**FIGURE R4.2-1**  
Alternative A Site Plan

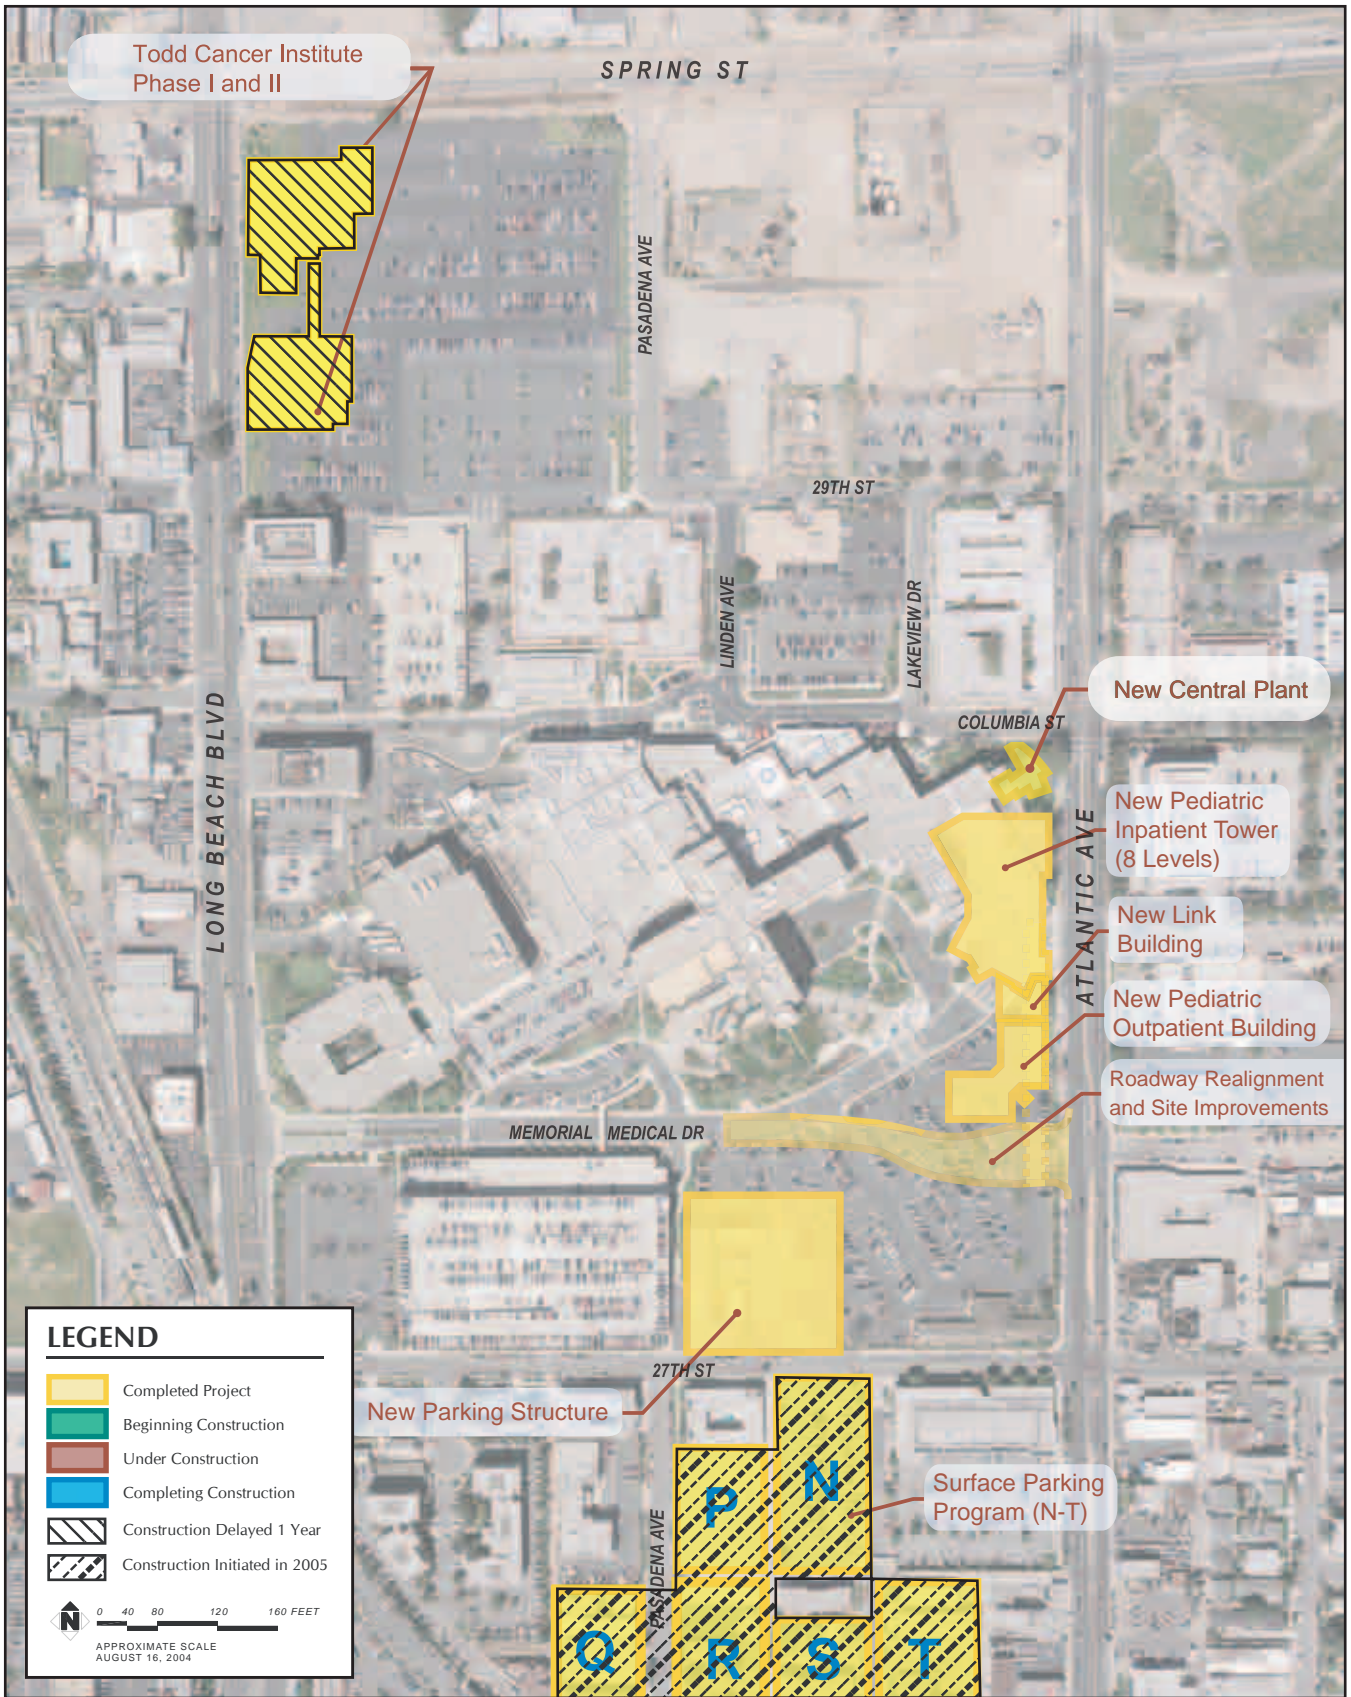
Page 4-11 The northeastern boundary of the Campus and the location of the central plant building were revised in Figure 4.2-1 and replaced by Figure R4.2-1.

In the first sentence of the first paragraph under this heading, please replace the reference to (Figure 4.2-1, *Alternative A*) with the following:

(Figure R4.2-1, *Alternative A*)

**FIGURE R4.3-1**  
Alternative B Site Plan

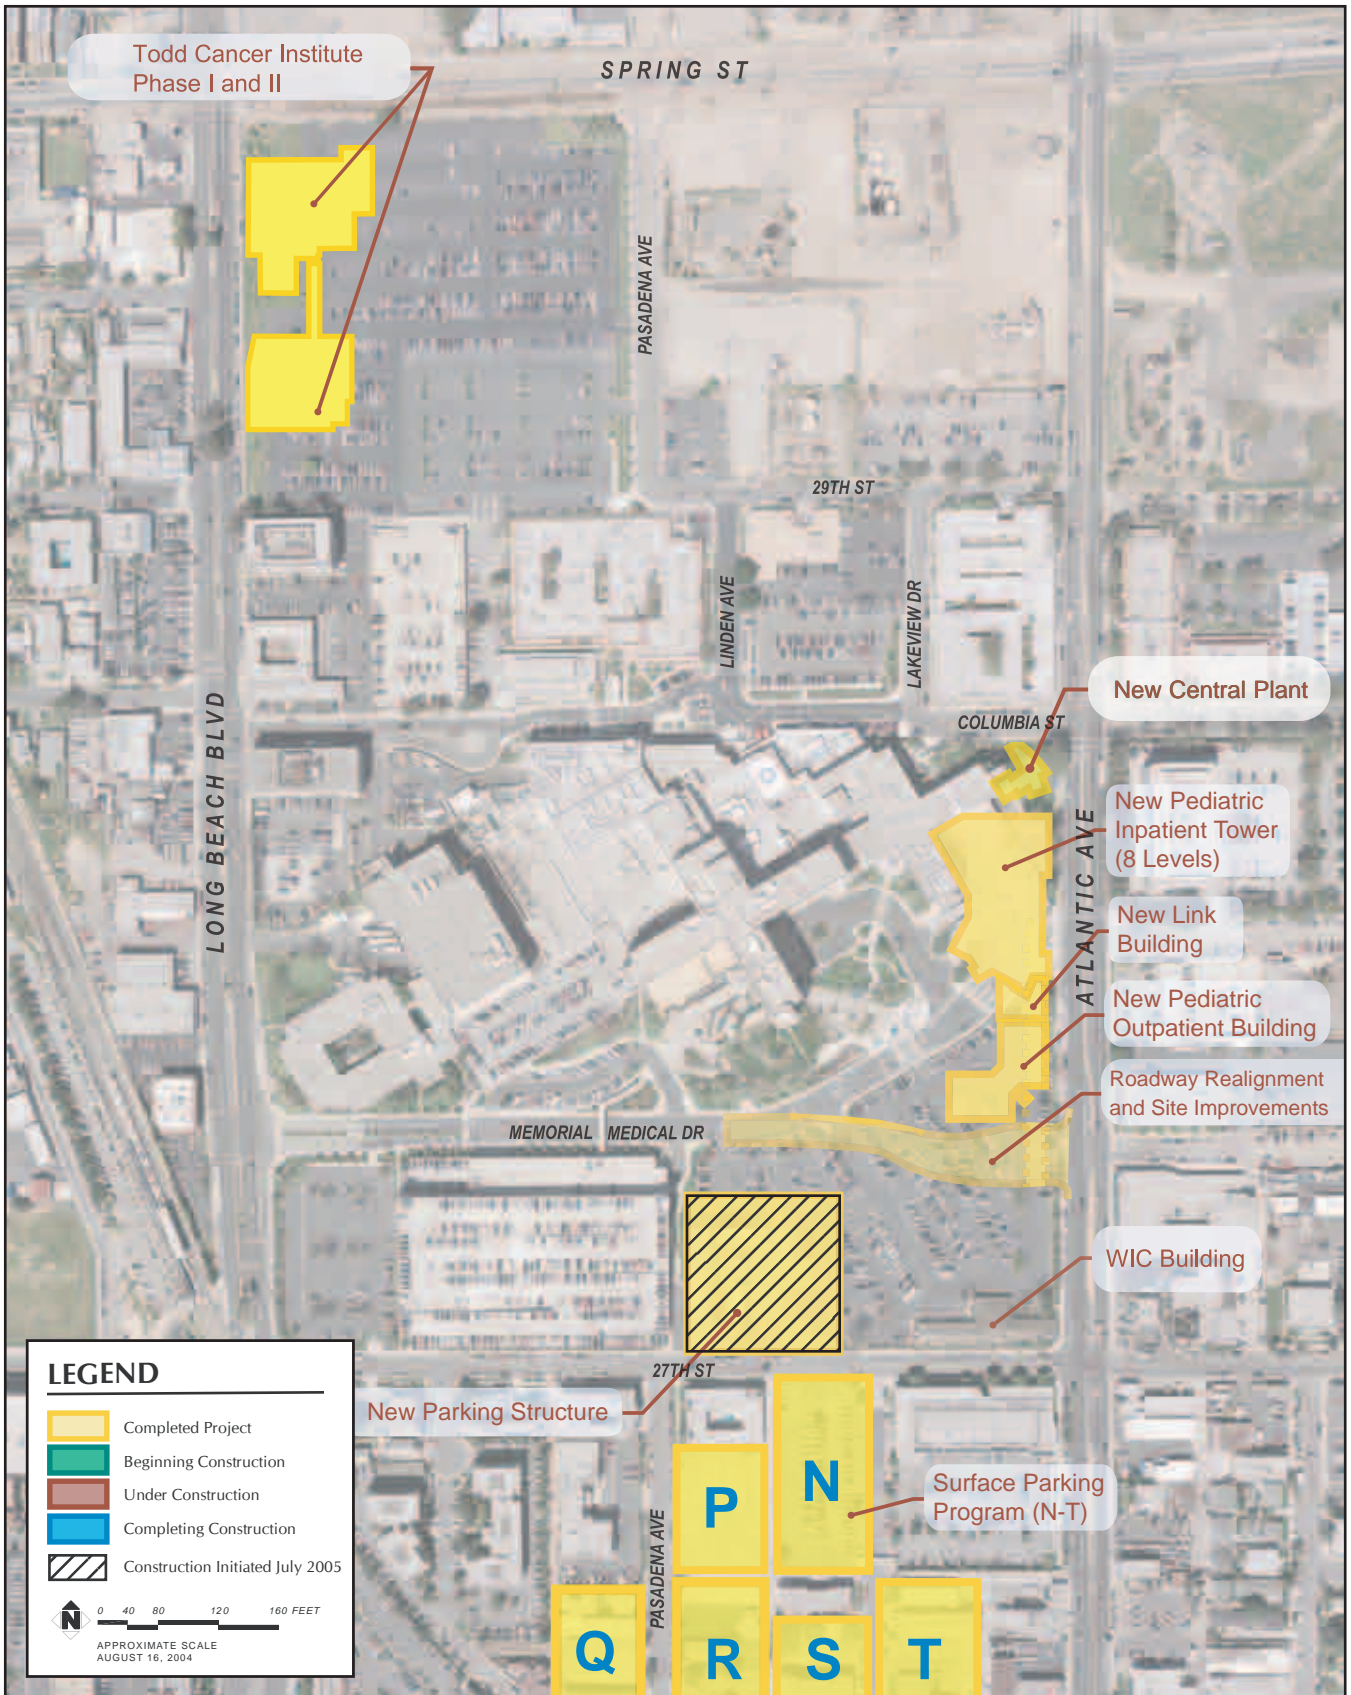
Page 4-20 The northeastern boundary of the Campus and the location of the central plant building were revised in Figure 4.3-1 and replaced by Figure R4.3-1.

In the first sentence of the first paragraph under this heading, please replace the reference to (Figure 4.3-1, *Alternative B*) with the following:

(Figure R4.3-1, *Alternative B*)
